25 October 2021

Draft Environmental Impact Statement [Inland Rail, Gowrie to Helidon (G2H) Project]

Thank you for inviting Toowoomba Regional Council (TRC) to comment on the draft Environmental Impact Statement (EIS) for the proposed Inland Rail, Gowrie to Helidon (G2H) project pursuant to Part 4 of the *State Development and Public Works Organisation Act 1971* (SDPWO Act).

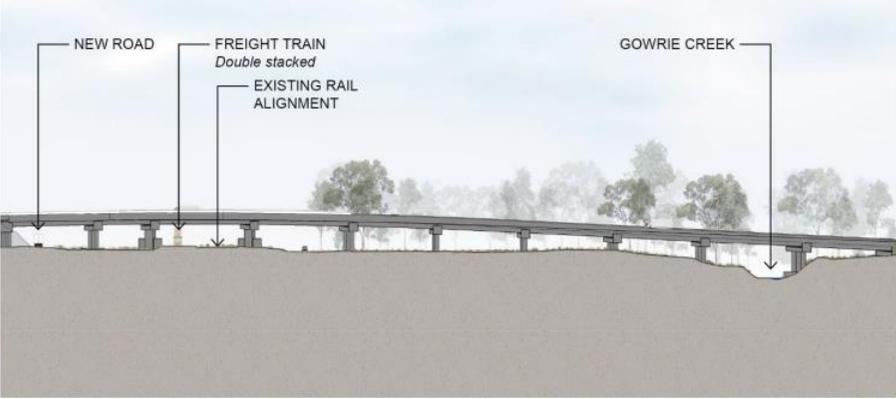
<p>78</p> <p>Section 10.4.2 (Significance Assessment Criteria) Section 10.6.3.3 (Lighting Impact Assessment) Table 10.4</p>	<p>Underestimation of Lighting Impacts at Critical Viewpoints: TOR 11.82 requires the draft EIS to ‘describe and illustrate the visual impact of the construction and operation of the project’ and ‘views should be representative of public and private viewpoints, including places of residence’.</p> <p>The visual impact that light at night has on private viewpoints is underestimated by representing the sensitivity of these receptors according to their daytime sensitivity level instead of their sensitivity to lighting, as specified in the methodology.</p> <p>Section 10.6.3.3 details the lighting impact assessment for each of the defined viewpoints. The methodology for this impact assessment, shown in Table 10.4, defines landscapes with ‘high sensitivity to lighting’ including ‘those with prolonged viewing opportunities located at very close distances</p>	<p>The lighting impact assessment requires reassessment to comply with the requirements of TOR 11.82 and Section 10.4.2 (significance assessment criteria) by re-evaluating the sensitivity and magnitude of change for critical viewpoints.</p>

#	EIS section and topic	Comment <i>What is the issue or what is suitable within the EIS</i>	Recommendation <i>What changes to the EIS or additional information is required?</i>
		<p>(typically less than 200 m) to the light source’ which describes private residences close to the proposed rail alignment.</p> <p>However, in its assessment of Viewpoints 4 and 5 (where there are residences within 200 m of operational light sources, namely train headlights) the sensitivity is described as moderate and low (respectively) using the daytime assessment criteria. These are not correctly assigned according to the methodology provided in Section 10.4 and will alter the overall evaluation of the significance of the effect.</p> <p>For Viewpoint 6, there are residences within 500 m of operational light sources, which would suggest that they should be considered moderate sensitivity but again they are considered low as per the daytime consideration. It appears that all sensitivity assessments for the lighting impact assessment have used the daytime evaluation and not the sensitivity to lighting (i.e., night-time) definitions set forth in Table 10.4.</p> <p>This is especially significant for Viewpoints 4, 5 and 6 as it is acknowledged that these viewpoints are near a crossing loop and may be subject to impacts from light at night due to stationary trains using the crossing loop. It is specifically mentioned that residences near Viewpoint 4 will have ‘transient light due to vehicle headlights which will be <u>highly evident</u> to residential properties situated in close proximity to the Gowrie Junction Road bridge’. However, all three viewpoints are assessed as having low magnitude of change in lighting assessment.</p> <p>Transient lighting associated with train headlights during operation is dismissed as having no significant impact in the magnitude of change assessment for lighting. While the light source in question is transient in nature, it is also frequent and regular enough (throughout the night) to warrant investigation of any residences near the track that could be impacted by obtrusive light, and an indication of how any potential issues would be resolved. Given the frequency of intended service, obtrusive light</p>

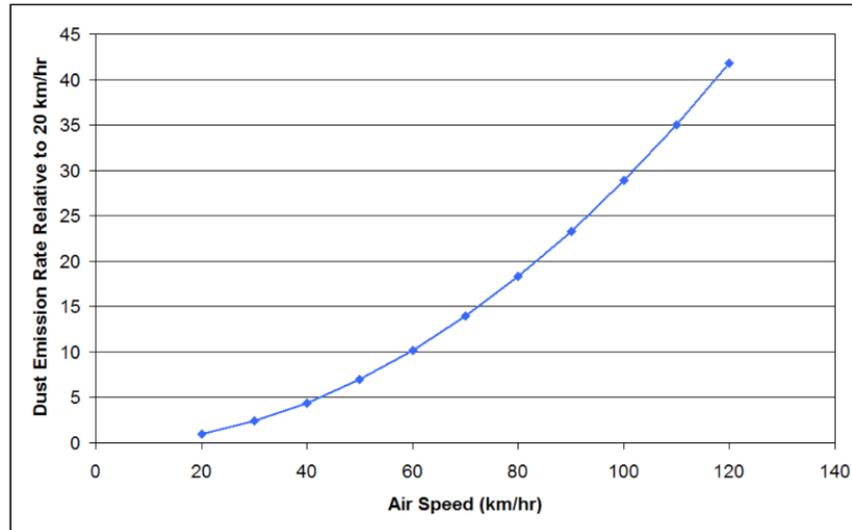
#	EIS section and topic	Comment <i>What is the issue or what is suitable within the EIS</i>	Recommendation <i>What changes to the EIS or additional information is required?</i>
	<p>The assessment of odour impacts does not meet TOR 11.131 as the assessment does not:</p> <ul style="list-style-type: none"> - Consider that the potentially affected localities are mainly within urban areas and <i>not rural areas</i> under the SEQ Regional Plan. Therefore, the premise that such odours are expected by the community is factually incorrect. - Adequately consider cumulative impacts of odour at receptors. If the population is already exposed to similar (livestock) odour from local agricultural activities, what impacts may occur to amenity from adding an additional odour source which is similar in character. - Furthermore, the assessment does not take into consideration the assimilative capacity with regards to livestock odours. - It is assumed that the six (6) livestock trains would be spread over a 1-week period, resulting in an average of less than one (1) train per day. However, there is no additional discussion regarding the likelihood of two (2) trains running on the same day. This would worsen the odour impacts at the sensitive receptors and the assessment does not provide enough discussion on this matter. - Additional analysis is also warranted regarding the estimated duration of a livestock train pass by which may be up to one (1) hour and comparing its intensity impacts to a more common form of livestock transport such as a livestock truck. This would seem like a considerably longer duration than say a livestock truck (which is understood given the significant proposed length of the trains). - Commentary would also be required on how the scale of livestock numbers on a livestock train compare to livestock numbers on a cattle truck. Presumably, a livestock train will be a more significant odour

#	EIS section and topic	Comment <i>What is the issue or what is suitable within the EIS</i>	Recommendation <i>What changes to the EIS or additional information is required?</i>
		source than existing modes of livestock transport given the significant difference in size between trucks and trains.	
102	Chapter 12 Appendix K Section 8 (Cumulative Impact Assessment)	Assessment of Cumulative Impacts: Table 8.3 of Appendix K lists at least three (3) facilities that are operational namely Wellcamp Business Park, Witmack Industry Park and the Harlaxton Quarry. Without providing any detailed information about these sources, the impact significance is categorised <i>low</i> and therefore, a detailed cumulative impact assessment has not been conducted and the draft EIS has not meet the requirements of TOR 7.3.	While it is acknowledged that there will be some lessening of adverse impacts to air quality due to the use of the proposed tunnel, the proposed alignment still traverses communities and can still result in adverse impacts to air quality. Given this, the Air Quality Technical Report should be revised to meet the requirements of TOR 7.3 and provide additional information regarding emissions released to air from these facilities, instead of a qualitative assessment.

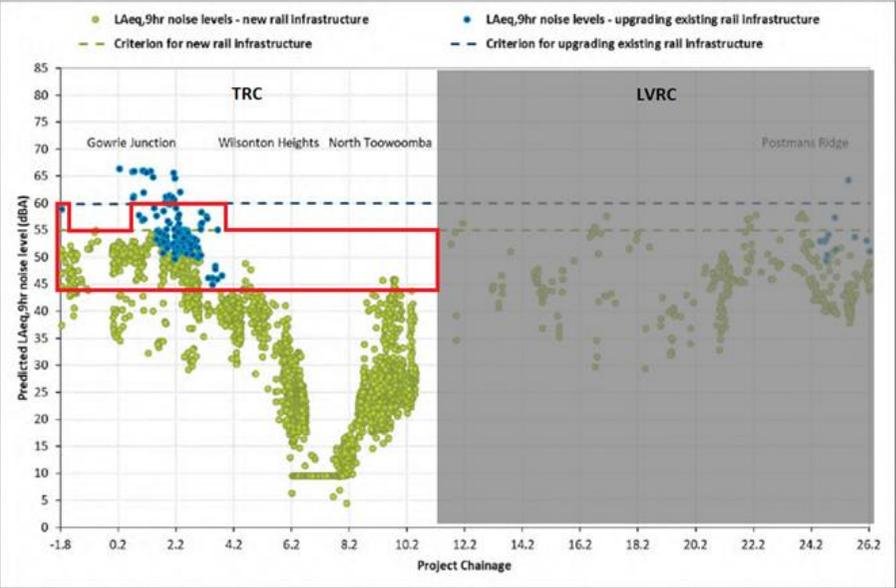
217	<p>Chapter 15 Appendix O Section 5.4.1 (Ground-borne Vibration – Construction)</p>	<p>Missing Assessment of Vibration Impacts from Hydraulic Hammers: Section 5.4.1 provides list of the formula that have been used to predict the vibration impacts from the construction equipment. Table 5.6 lists the equipment types that have been used and includes, impact piling, vibratory piling and vibratory rolling. While each of these methods will introduce elevated levels of vibration at some locations along alignment, the assessment has not considered the impact from large scale hydraulic hammers which will necessarily be used in multiple areas. The level of vibration from the vibratory roller or piling may be applicable for some areas of the assessment however it would be beneficial for residents along the alignment which may be potentially affected to understand the impacts from equipment that might be used near their properties. As a minimum, it would be appropriate to compare the vibration from the hydraulic hammer with that from the vibratory roller.</p>	<p>The draft EIS requires update to appropriately assess adverse noise and vibrational impacts from the use of hydraulic hammers in order to meet the requirements of TOR 5.1 and TOR 5.3.</p>

#	EIS section and topic	Comment <i>What is the issue or what is suitable within the EIS</i>	Recommendation <i>What changes to the EIS or additional information is required?</i>
		As a result, the draft EIS fails to meet the requirements of TOR 5.1 (which requires 'all relevant environmental, social and economic impact of the project are identified and assessed...') and TOR 5.3, which requires the consideration of 'matters relevant to the project' in relation to 'intensity, duration, cumulative effect, irreversibility, the risk of environmental harm, management strategies...'	
218	Chapter 15 Appendix O Section 5.5.3 (Construction Vibration Impacts)	<p>Inappropriate Setback Distances: Section 5.5.3 of Appendix O assesses the vibration impacts from the vibratory rollers and piling options and tabulates the set-back distances required to achieve compliance with the with proposed vibration criteria. When compared to other projects, the setback distances are significantly higher than expected and could lead to unnecessary concern by residents within the zone calculated by this set back distances, or possibly an unnecessary change to the practices that contractors may adopt, leading to an increased project duration and overall impact.</p> <p>As a result, the draft EIS fails to meet the requirements of TOR 5.3 as the consideration of 'matters relevant to the project' is not 'proportional to the scale of the impacts on environmental values.'</p>	The draft EIS requires update in order to meet the requirements of TOR 5.3.

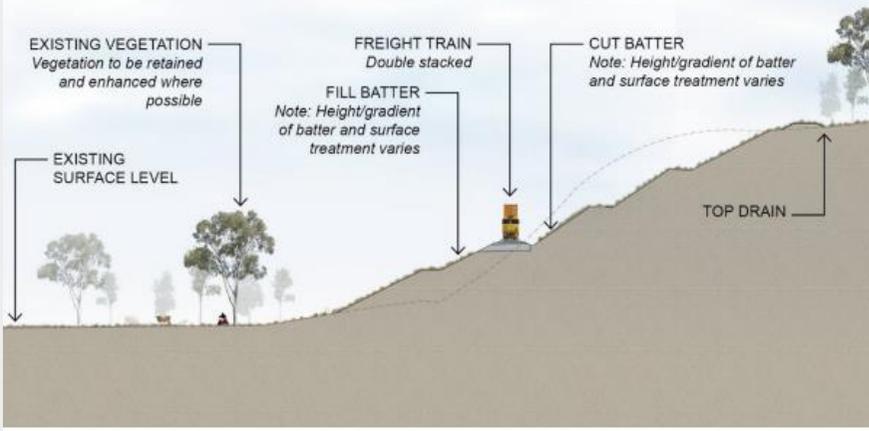
282	Appendix F Section F3 (Detailed Design Phase) Table F3.1, ID D18	<p>Lack of Commitment to Mitigate Obtrusive Light Impacts: TOR 11.84 requires the draft EIS ‘describe any proposed measures to avoid, minimise or mitigate potential impacts on landscape character and visual amenity’ and TOR 11.93 requires that the draft EIS ‘describe any proposed measures to avoid, minimise or mitigate potential impacts on natural values, and enhance these values’ ... ‘in particular, address measures to protect or preserve any threatened or near-threatened species.’</p> <p>The proponent commitment wording does not comprehensively address obtrusive light issues.</p>	<p>The draft EIS requires update to meet the requirements of the OCG’s TOR and to appropriately assess obtrusive lighting concerns, including proponent commitments.</p>

#	EIS section and topic	Comment <i>What is the issue or what is suitable within the EIS</i>	Recommendation <i>What changes to the EIS or additional information is required?</i>
		<p>Addressing commitments related to landscape and visual amenity, item D18 in Table F3.1 states that the Project landscape design will develop treatments, landscaping and stabilisation at ‘key view-points identified in the EIS.’</p> <p>As outlined previously, significant problems can arise related to obtrusive light during construction and operation phases, where the area of concern is not aligned precisely to the viewpoints identified in the draft EIS. Design actions related to obtrusive light concerns should be included in proponent commitments.</p>
